Subject: Juanita Bay Townhomes Final Subdivision, File No. FSB08-00001

MEMORANDUM ADVISORY REPORT FINDINGS, CONCLUSION, AND RECOMMENDATIONS

To: Eric R. Shields, AICP, Planning Director
From: Tony Leavitt, Associate Planner
Date: July 23, 2008
File: JUANITA BAY TOWNHOMES FINAL SUBDIVISION, FILE FSB08-00001

JUANITA BAY TOWNHOMES
PRELIMINARY PLAT
PRELIMINARY PLAT/MAP
KIRKLAND, WASHINGTON

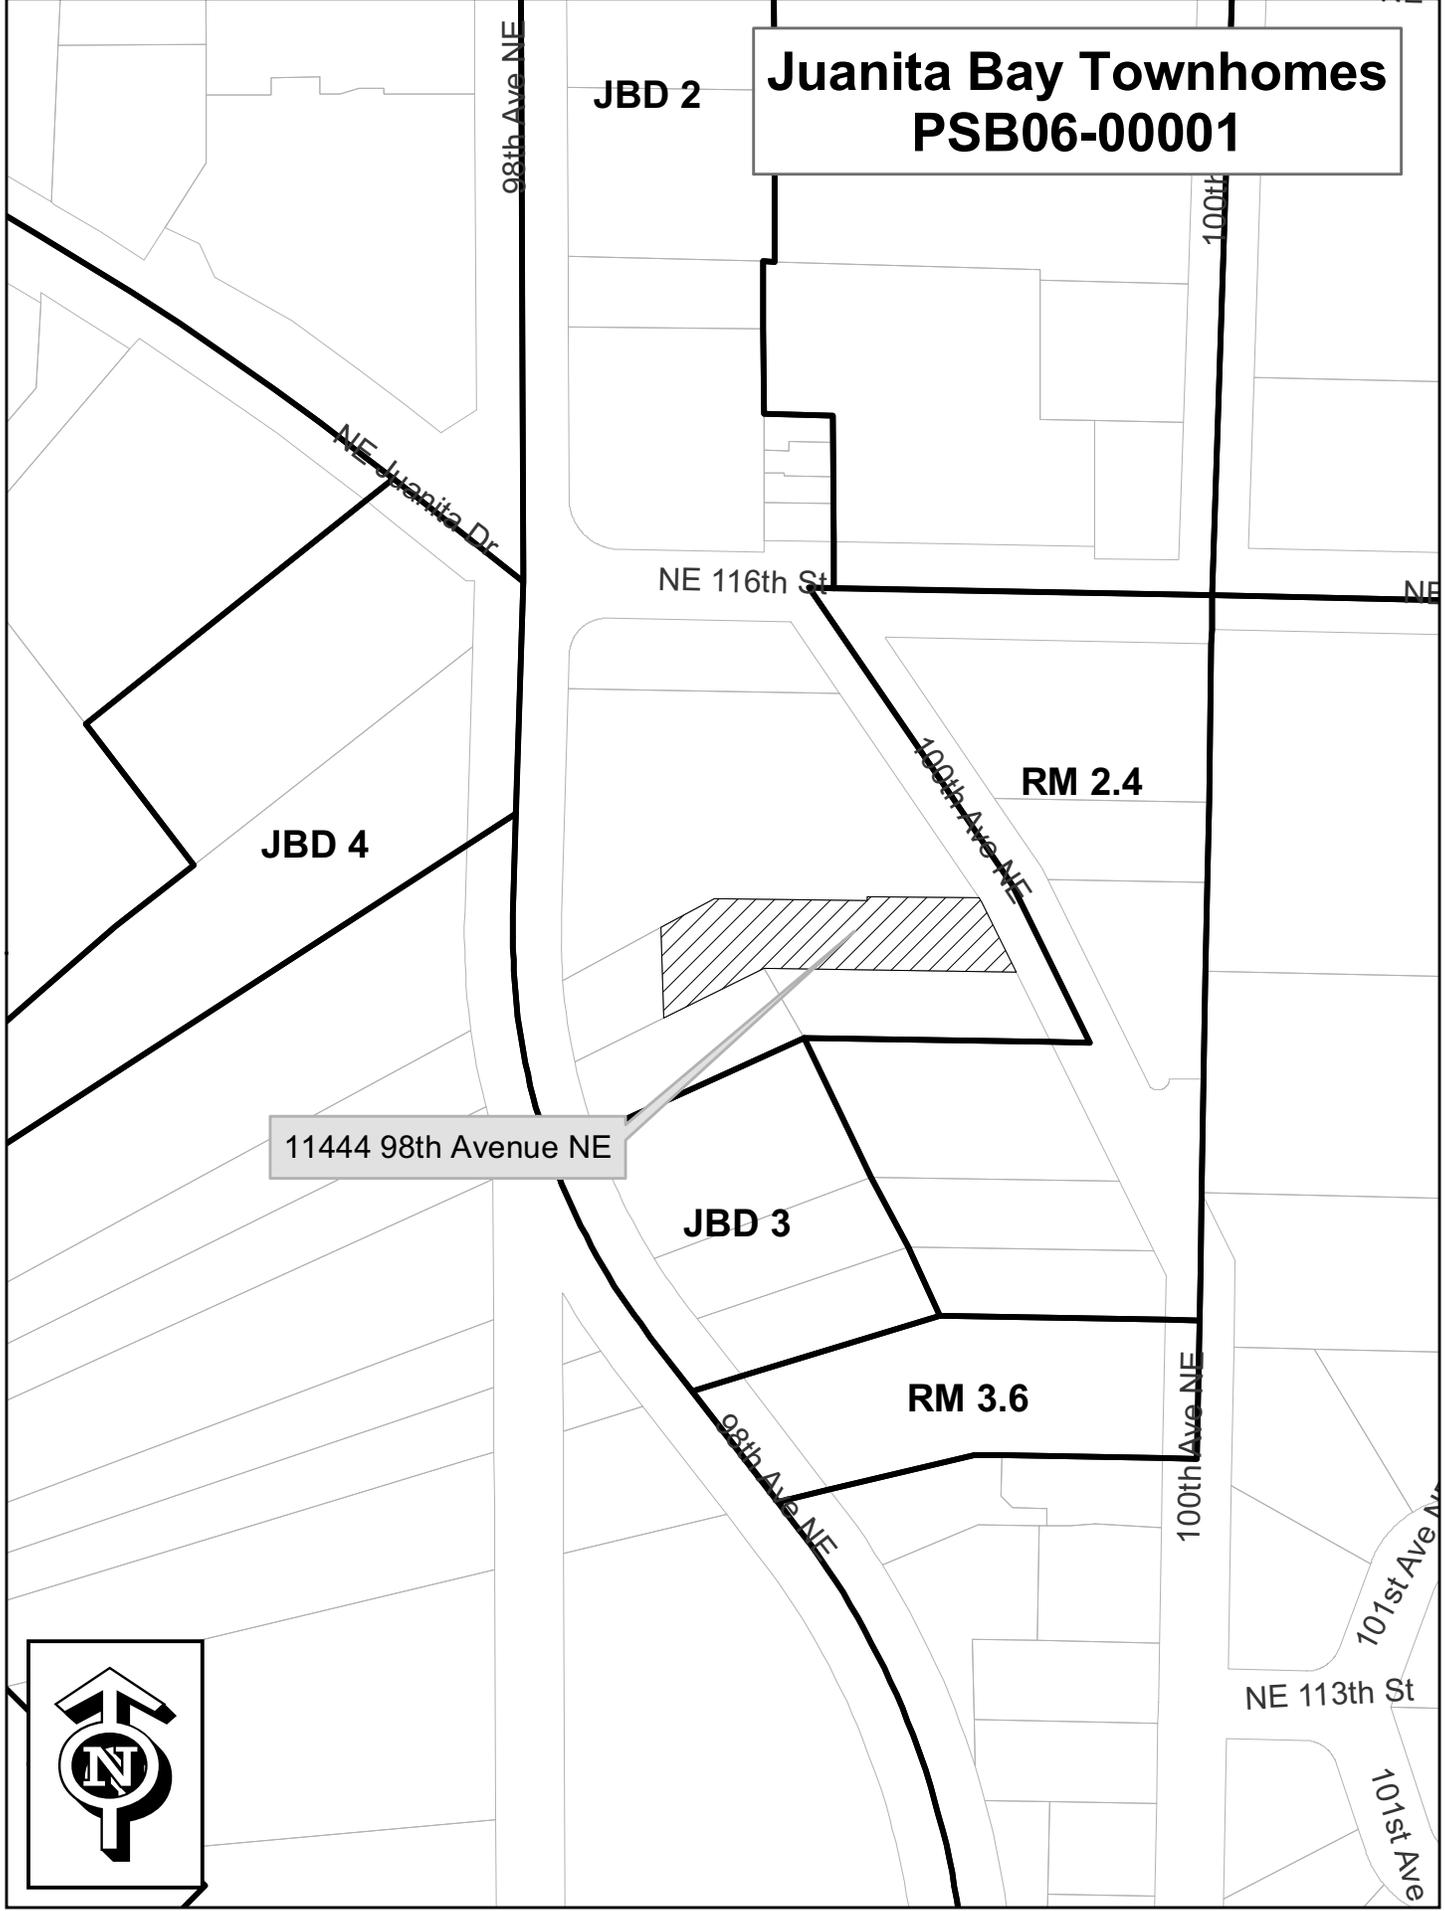
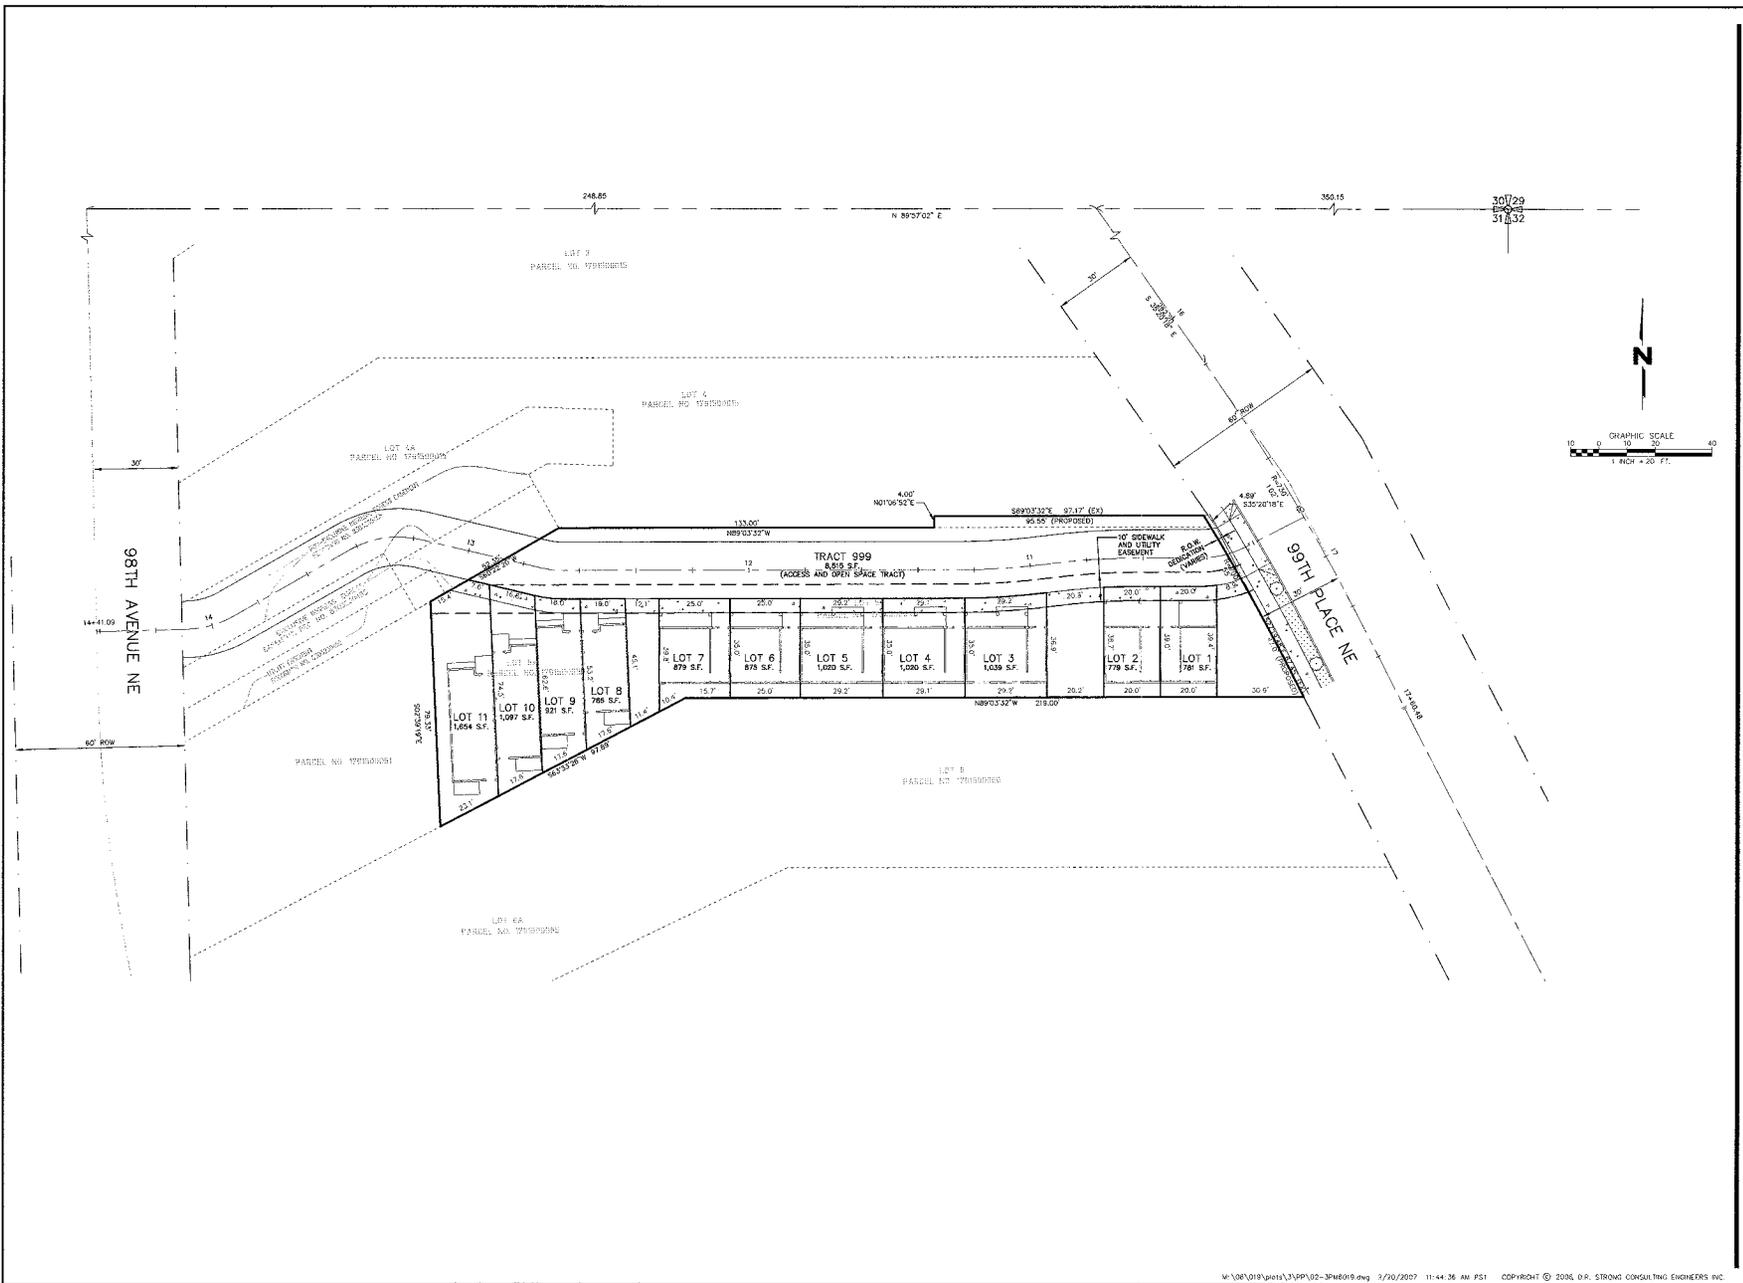
The proposed lot lines as shown do not accommodate the buildings submitted under NSFR permit applications BLD07-00159 through BLD07-00169. Please revise the Plat Map to comply with IRC section R302.2 below as follows:
